AUTOMATIC TRANSMISSION SERVICE GROUP

REVISED EDITION

Since the introduction of the THM 440-T4 Transaxle in April, 1984, there have been many major engineering design changes. These changes have affected nearly every part used in the THM 440-T4. This Update Handbook will explain each change, the parts affected by the change, and any parts interchangeability problems created by the change.

Figure 53

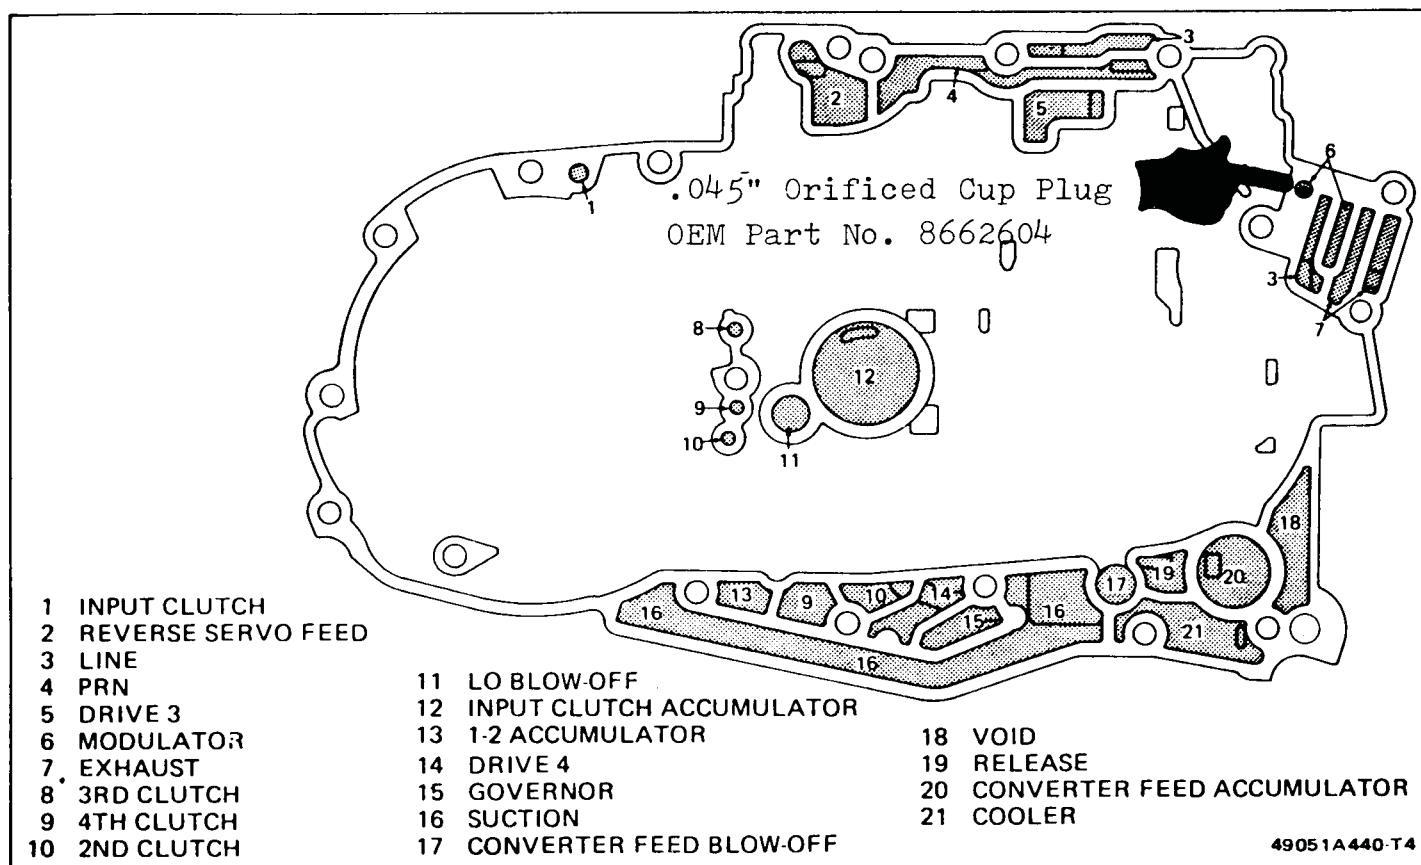
- 1) Vacuum Modulator - Late design has plunger sticking out of modulator (See Figures 54 and 55).
- 2) Modulator Valve - Redesigned to be compatable with "Plunger" style modulator. (Stem Removed--See Figures 54 and 55).
- 3) Channel Plate - Orificed cup plug added to channel plate to stabilize modulator valve action (See Figure 53).

Figure 54

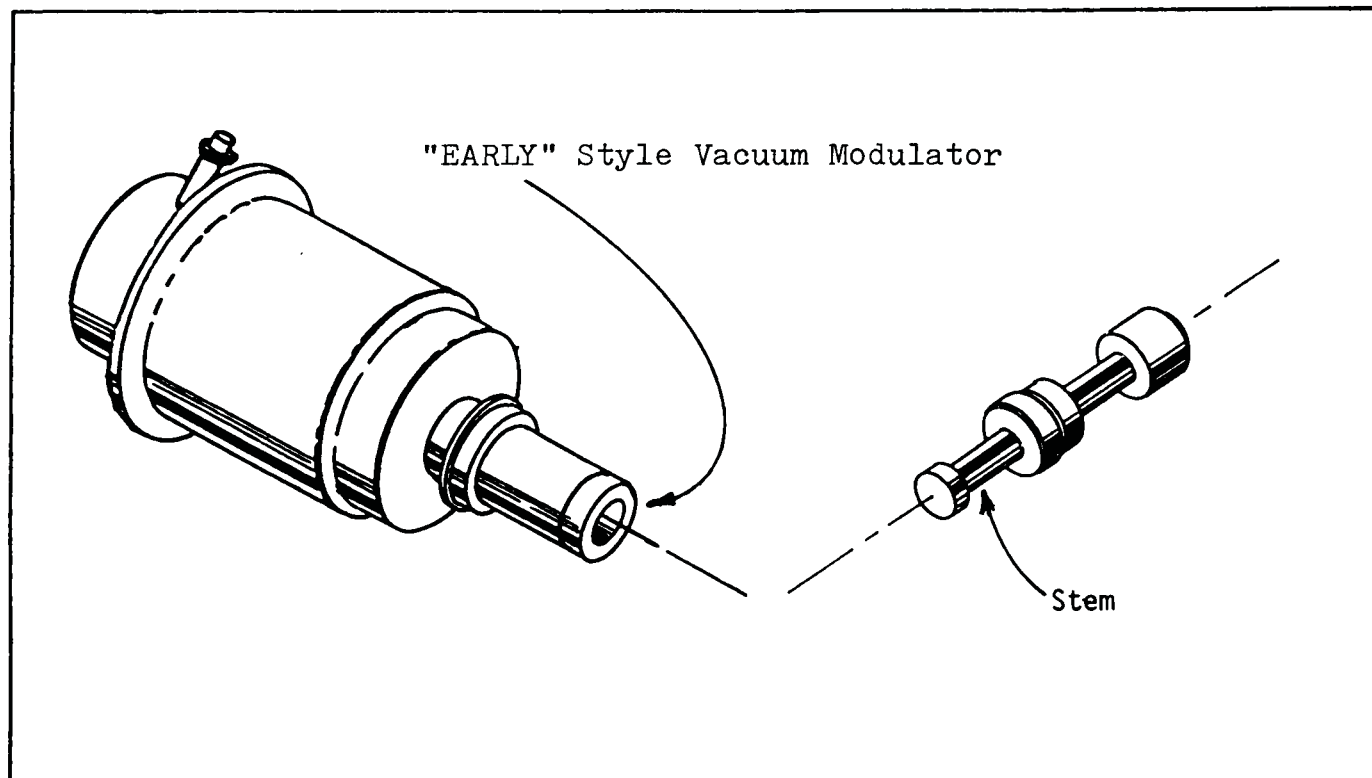
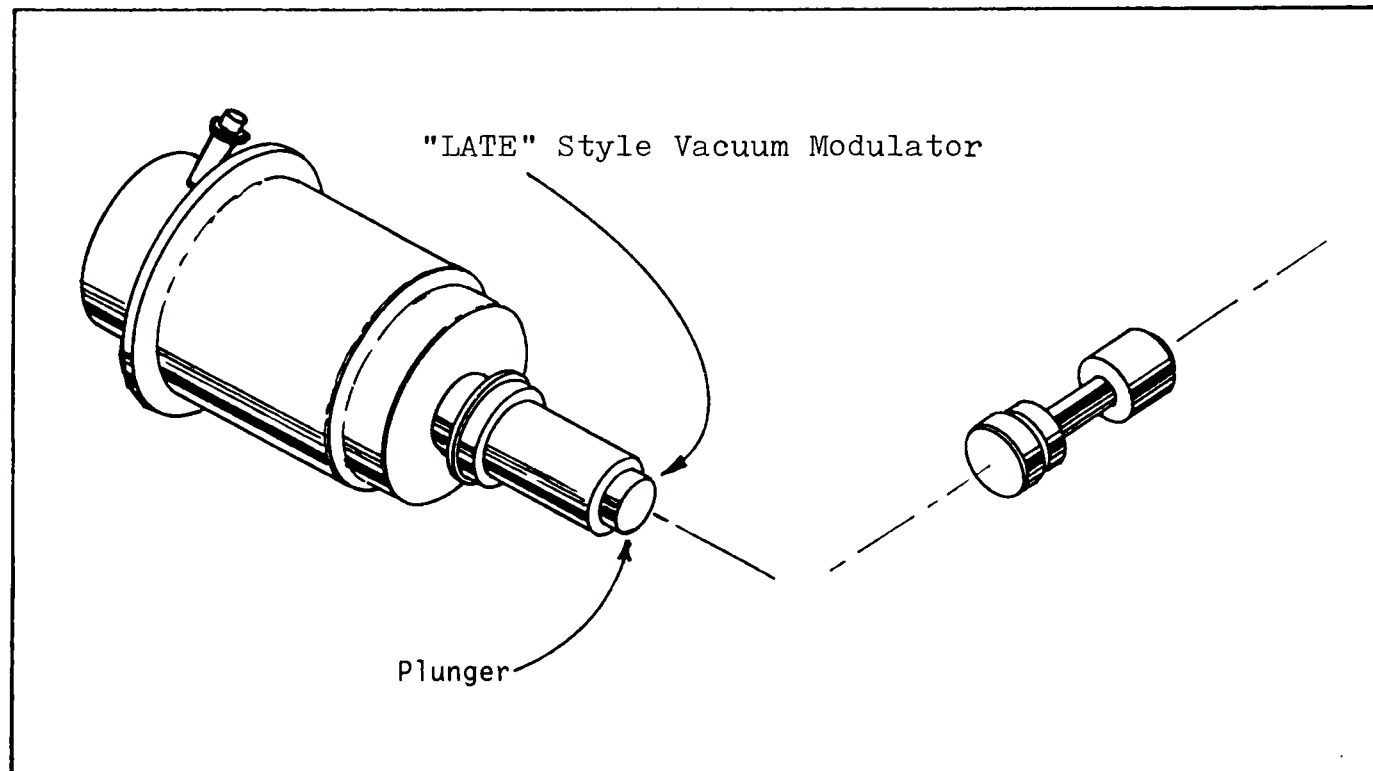
Change: Modulator redesigned on the end that goes into transaxle.
(Compare Figures 54 and 55). Occured Approx. July, 1986.

CAUTION: Be certain, if changing modulators, that you have compatable parts together. You cannot install the late style modulator on top of the early style valve, but you can go the other way very easily.

Figure 56

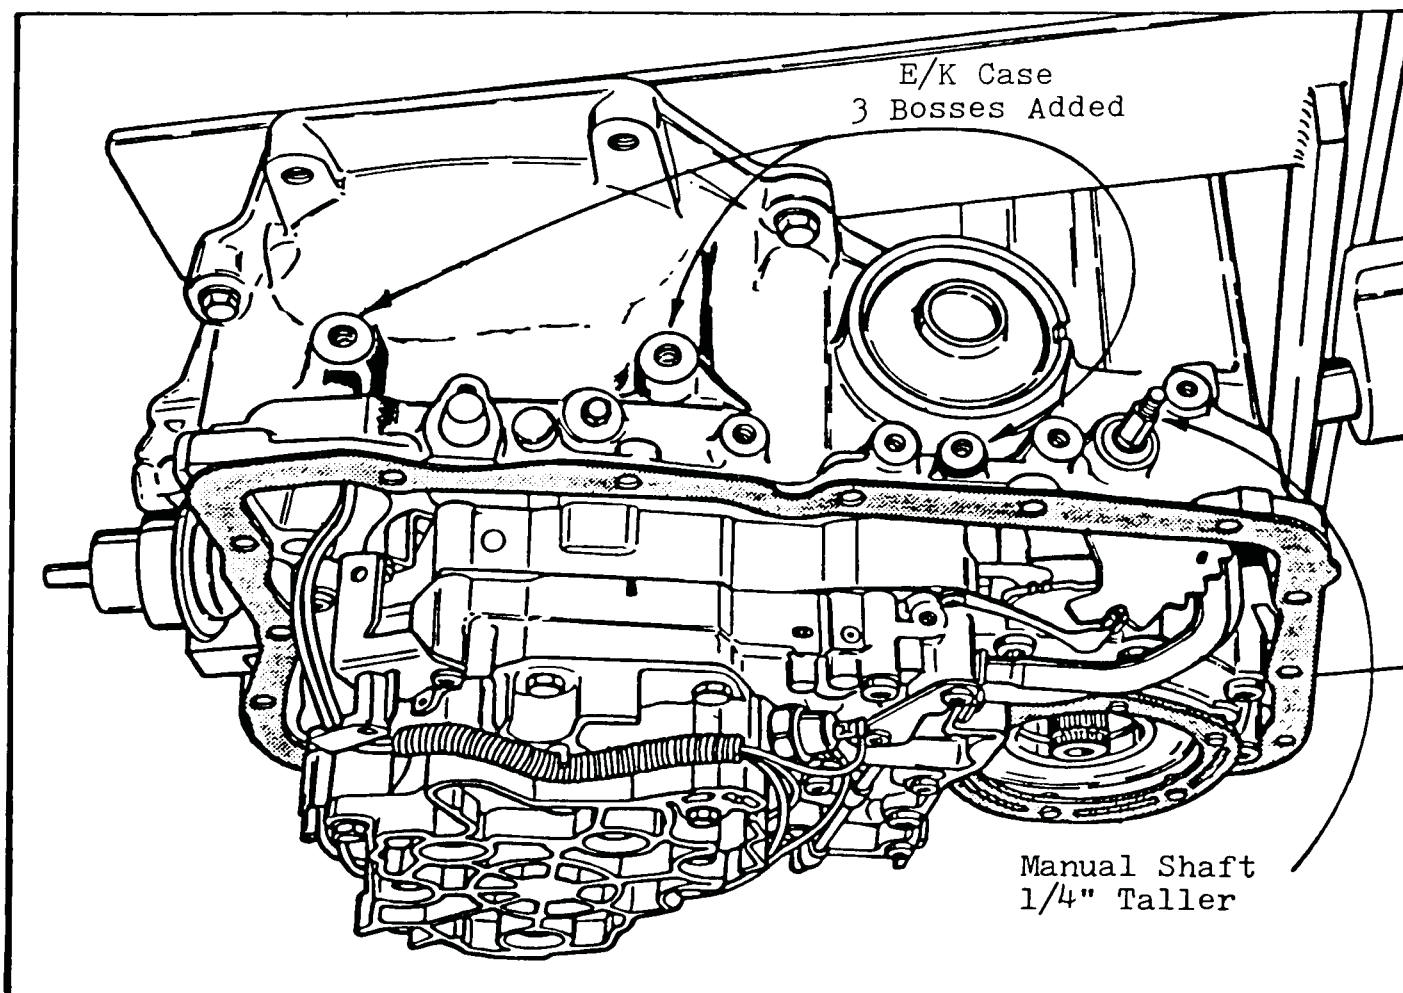
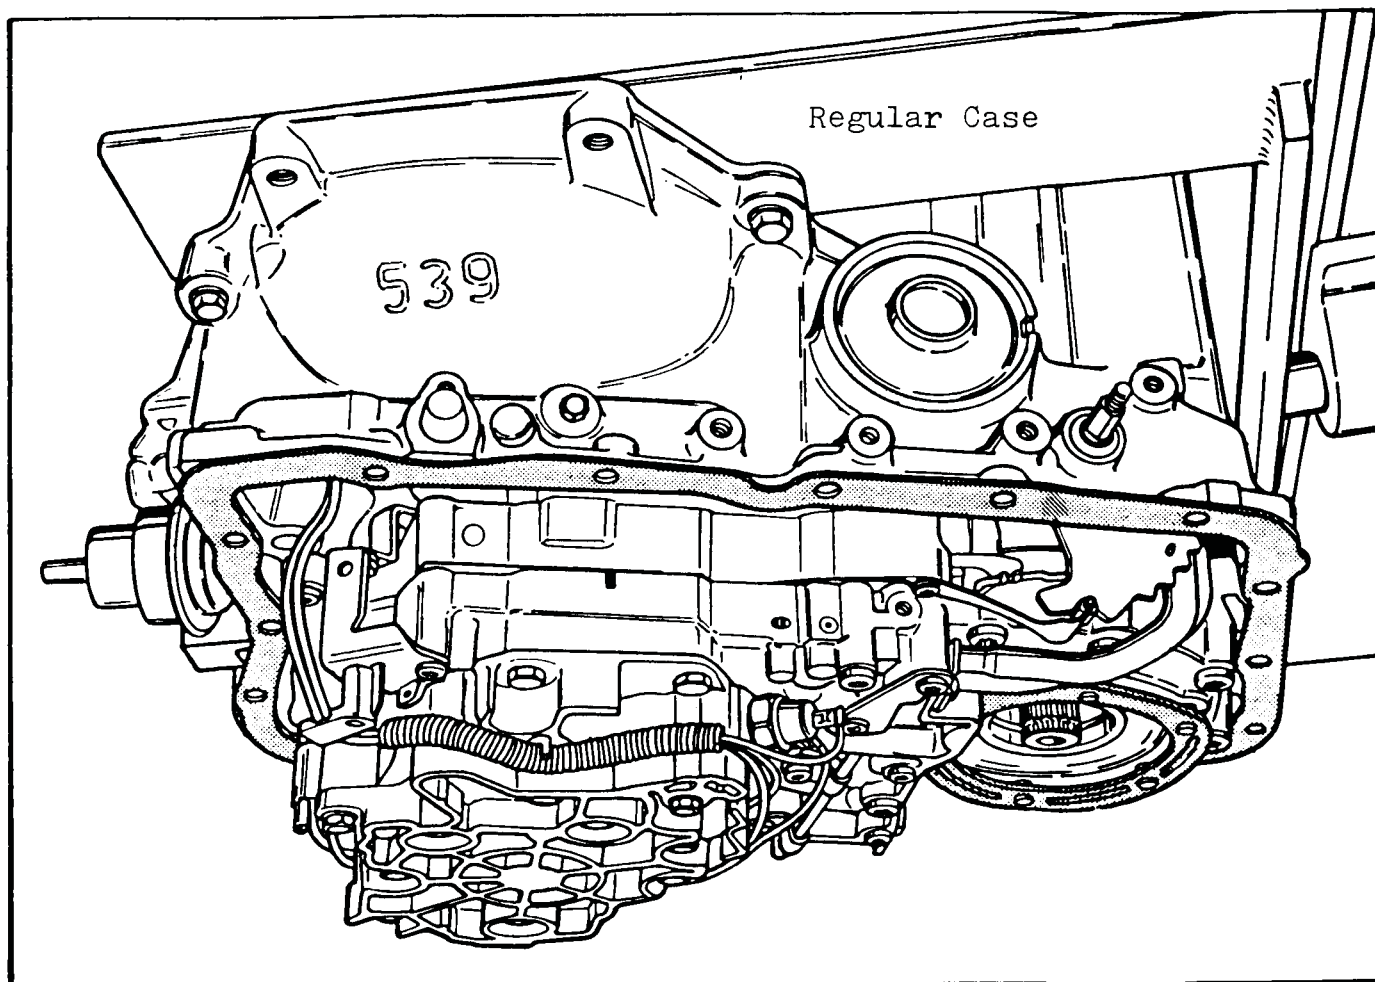
Change: Transaxle Case Assembly - 3 bosses added to transaxle case assembly (See Figures 56 and 57).

- 1) Transaxle Case - 3 bosses added to the case assembly (See Figures 56 and 57). The larger bosses on top of the case are for mounting purposes in the "E" and "K" bodies only. The smaller boss is for fuel line bracket in the "E" and "K" bodies only (See Figure 56). We can immediately see why it is called the E/K case.
- 2) Manual Shaft - The manual shaft is 1/4" longer on the E/K cars only.

Will retro fit backwards, but would not be smart to waste an E/K case on a non E/K vehicle, as they are in short supply.

Figure 67

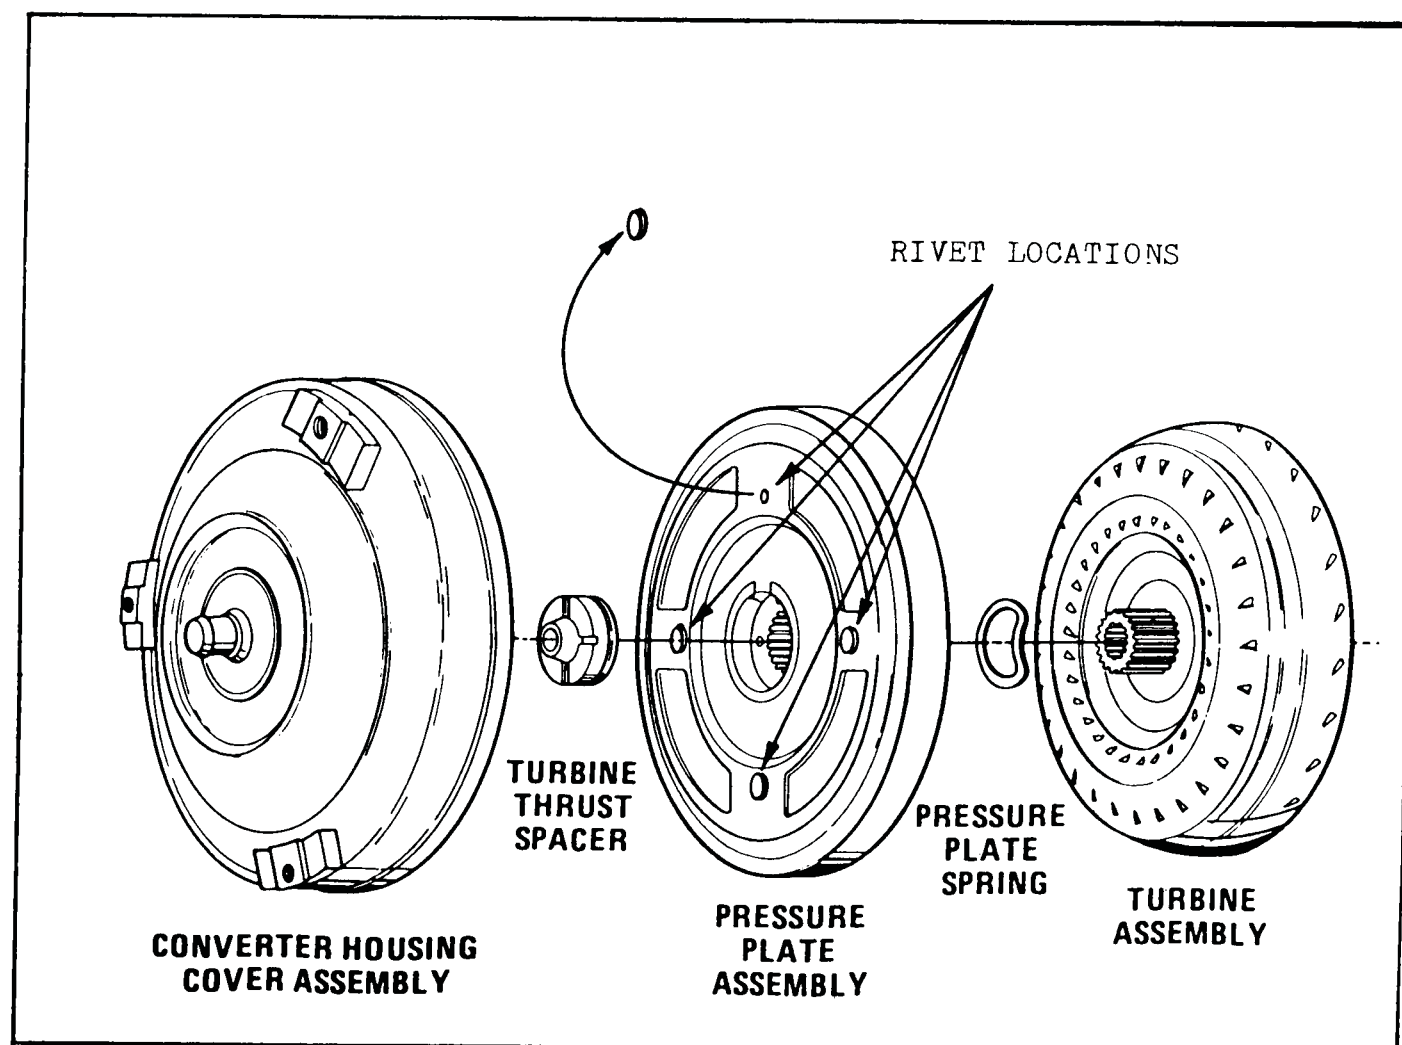
Some models of the THM 440-T4, usually with the 3.8L engine, may exhibit a TCC shudder condition or no torque converter clutch, because of a rivet head popping off that retains the damper assembly to the pressure plate (See Figure 67).

A torque converter checking fixture should be used on all 3.8L converters to verify converter clutch operation before installation.

Figure 68

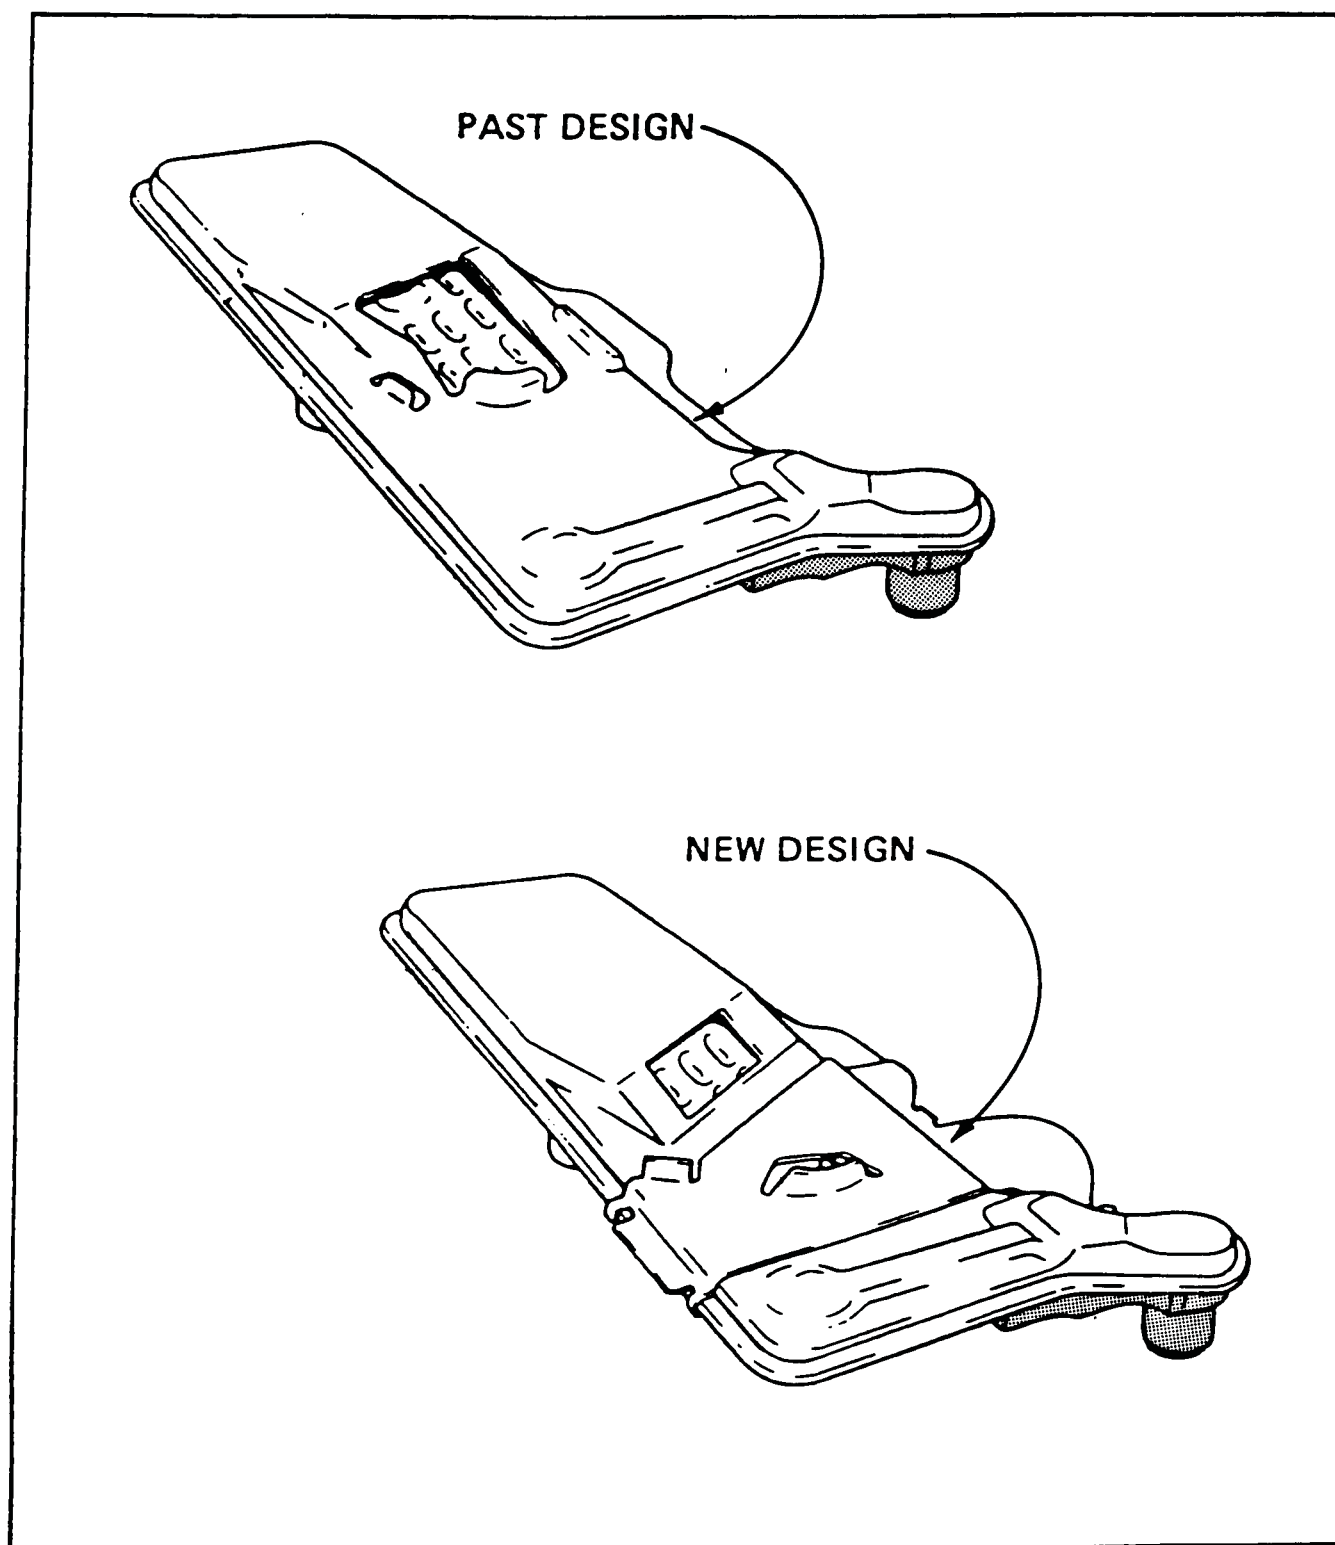
CHANGE: Oil Filter Assembly - Added baffles to oil filter and revised inlet (See Figure 68).

Additional baffles were installed on the new design filter and the inlet was revised (See Figure 68). Starting April 6, 1987 (Julien Date 096), all THM 440-T4 transaxles were built using the new design filter with the new inlet and baffle design.

Figure 69

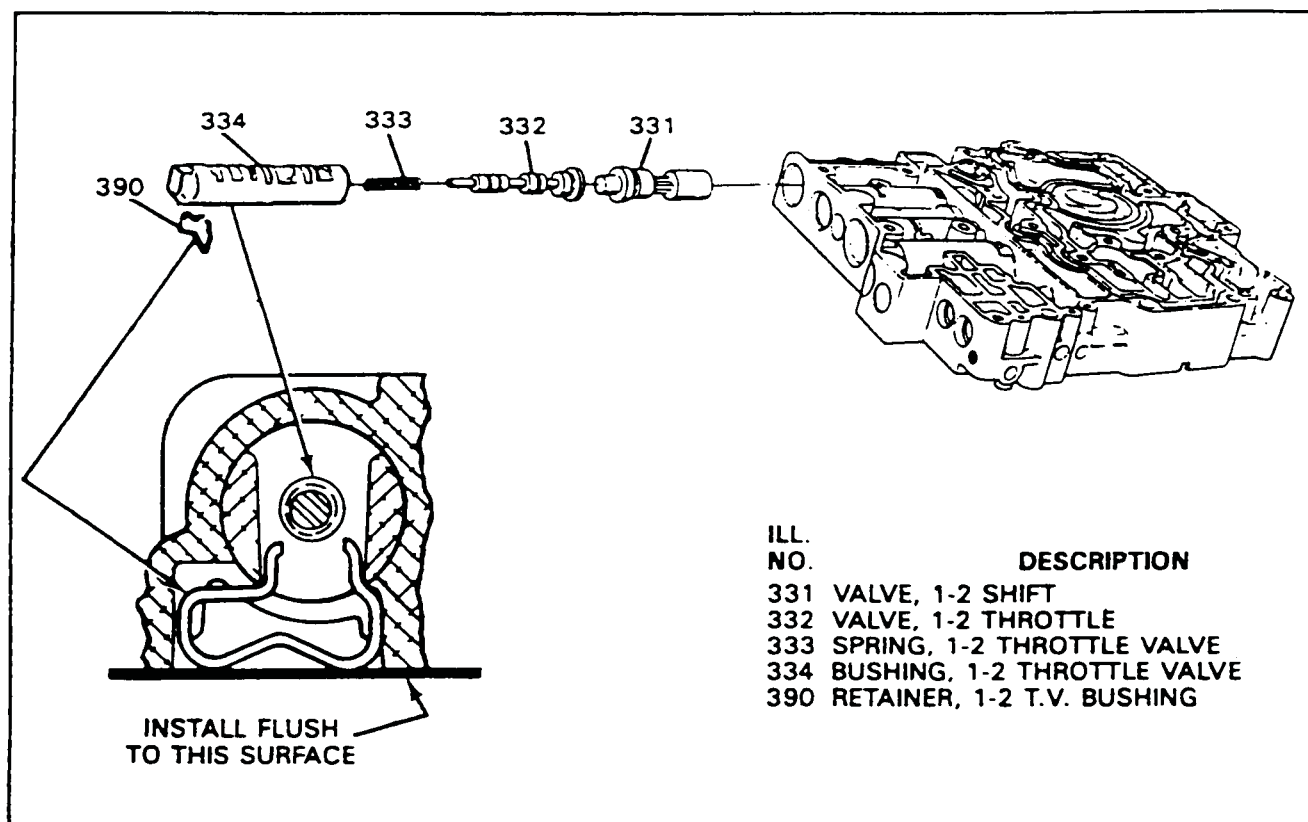
CAUSE: The cause may be the 1-2 throttle valve bushing retainer (390) pushed in too far (See Figure 69). If the retainer is pushed in too far the "Legs" of the retainer will grab hold of the 1-2 throttle valve, and the result will be 2nd gear starts.

CORRECTION: Install the retainer so that it is flush with the machined surface of the valve body (See Figure 69).

NOTE: The bushing must be installed as shown in Figure 69, with the angled surface on the end of the bushing toward the channel plate.
